APPLICATION NO.	FILING DATE	FIRST NAMED INVENTOR	ATTORNEY DOCKET NO.	CONFIRMATION NO.
10/655,176	09/04/2003	Krzysztof Barnat	EH-10831(03-359)	6785

Office Action Summary

DETAILED ACTION

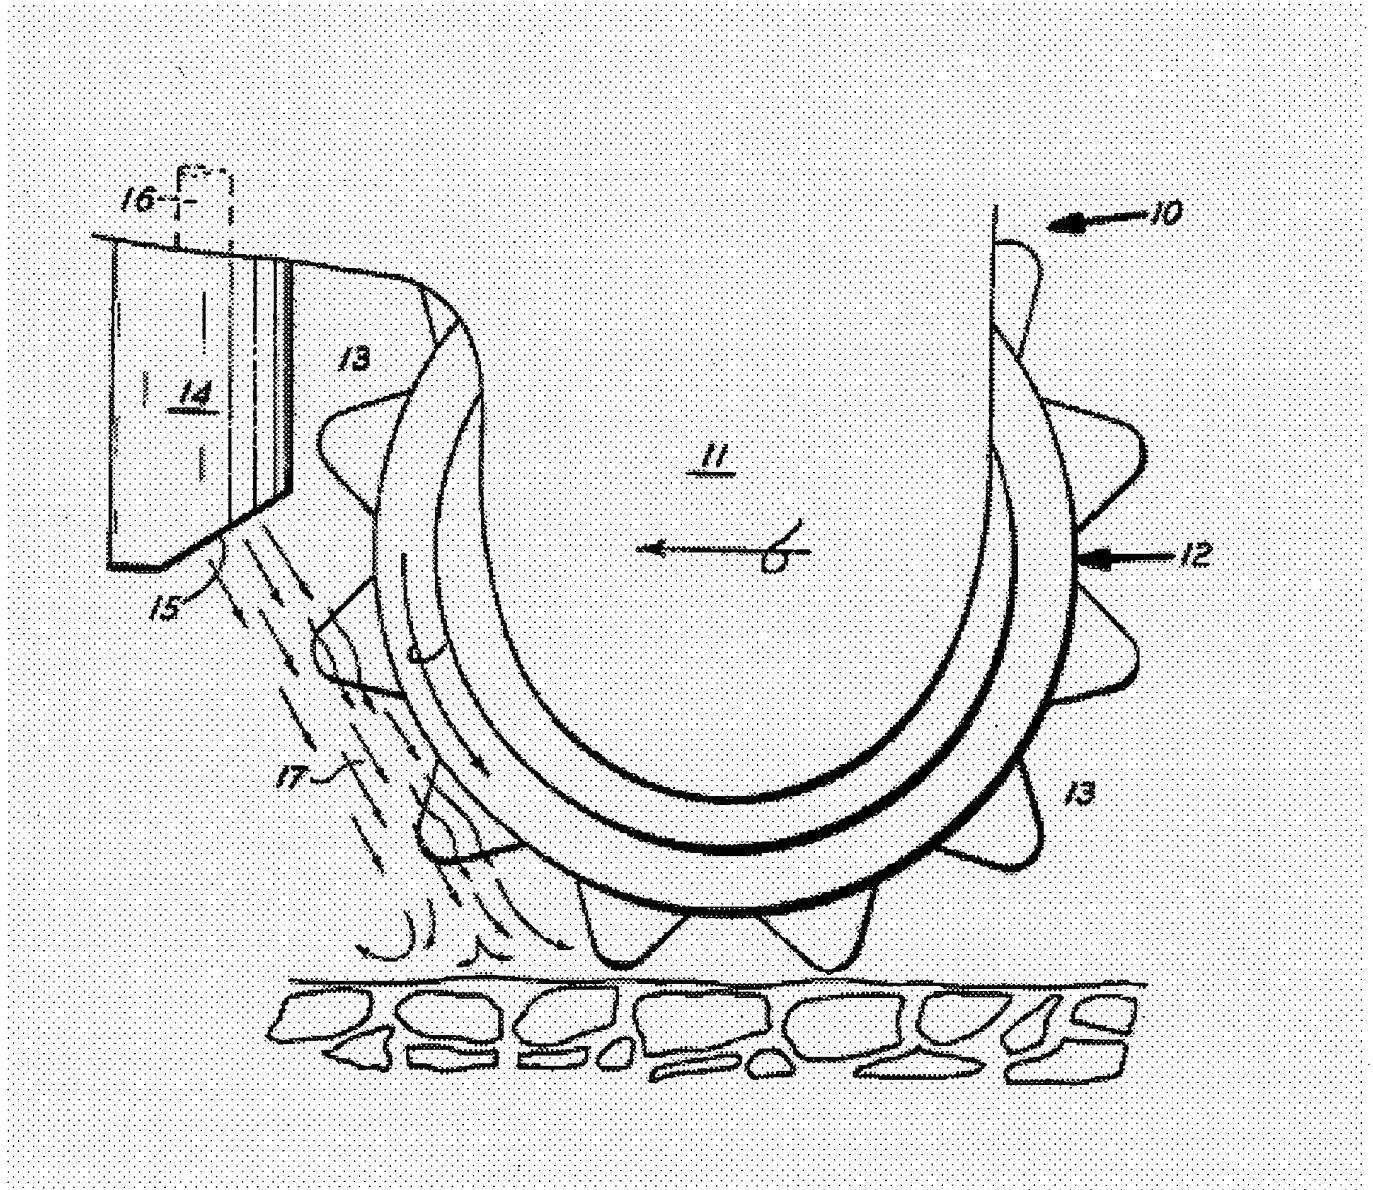
With reference to Figure 1, col. 2, line 1-42, Slaughter discloses the claimed invention including: a) a convoluted rotating bit 10; b) a coolant nozzle positioned to direct a coolant stream tangentially at the bit in a direction of rotation of the bit. Please note that the limitations of "for cutting a plurality of slots in a disk" is interpreted as the intended use; thus, Slaughter's rotating bit is capable of cutting slot in a disk. Furthermore, in col.

2, lines 38-42, Slaughter suggested the desirability of strengthening the nozzle to prevent it from being blown out of the opening by the drilling fluid under pressure.

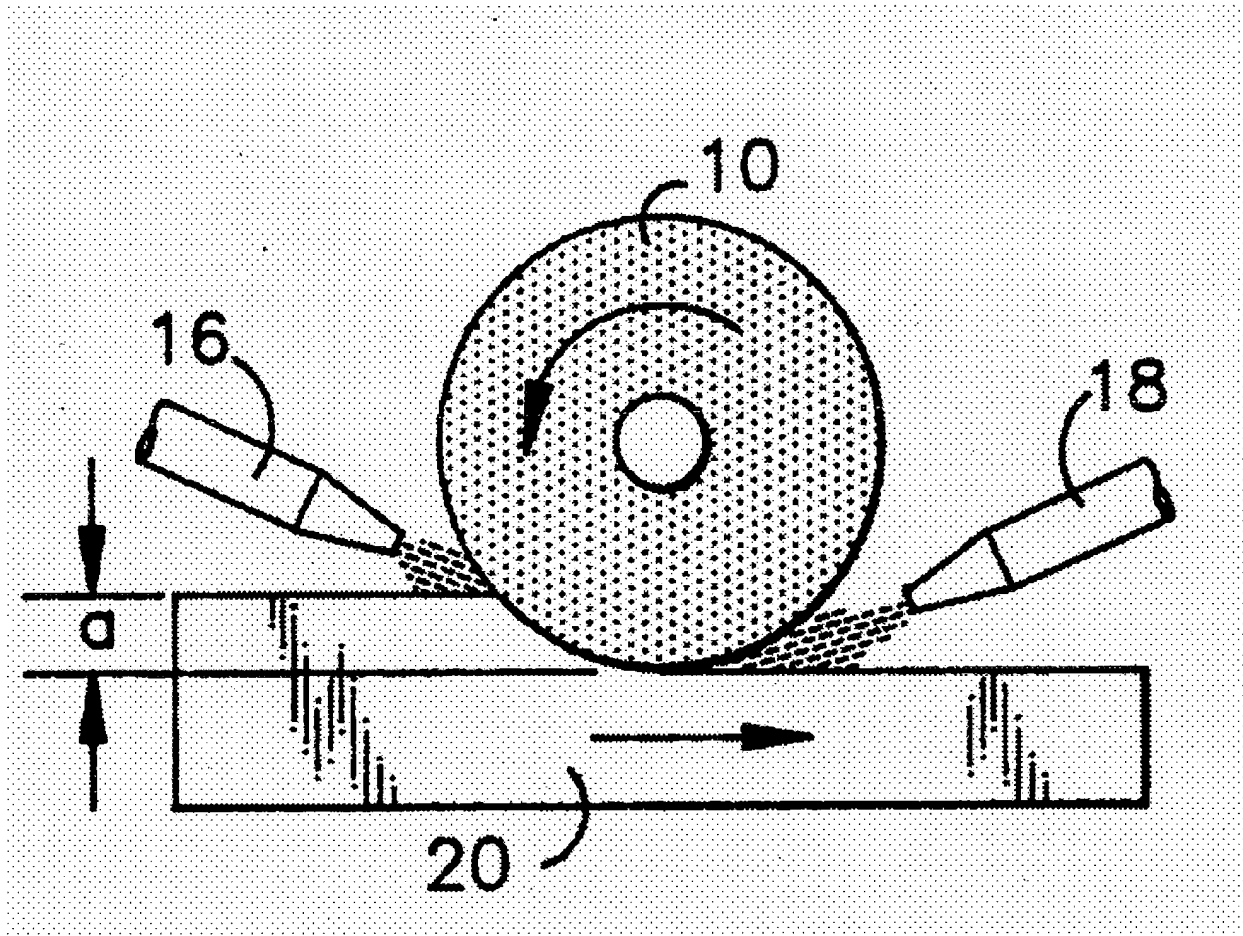
With reference to Figure 1, col. 2, lines 46-50. Cornelius discloses a spraying nozzle having a convoluted inner surface 3. The advantage of the convoluted inner surface of the nozzle contributes to the resistance to distortion of the nozzle during use.

45 The convoluted inner surface of the hollow tube may vary from structures in which simple rounded or pointed projections are directed into the lumen of the tube to more complex structures in which the projections may have interdigitating side branches. The convoluted inner surface of the tube
50 contributes to the resistance to distortion of the tube during use.

Thus, it would have been obvious to one having ordinary skill in the art at the time the invention was made to have modified Slaughter's nozzle with a convoluted inner surface as taught by Cornelius'265 in order to strengthen the resistance to distortion of the nozzle during use.
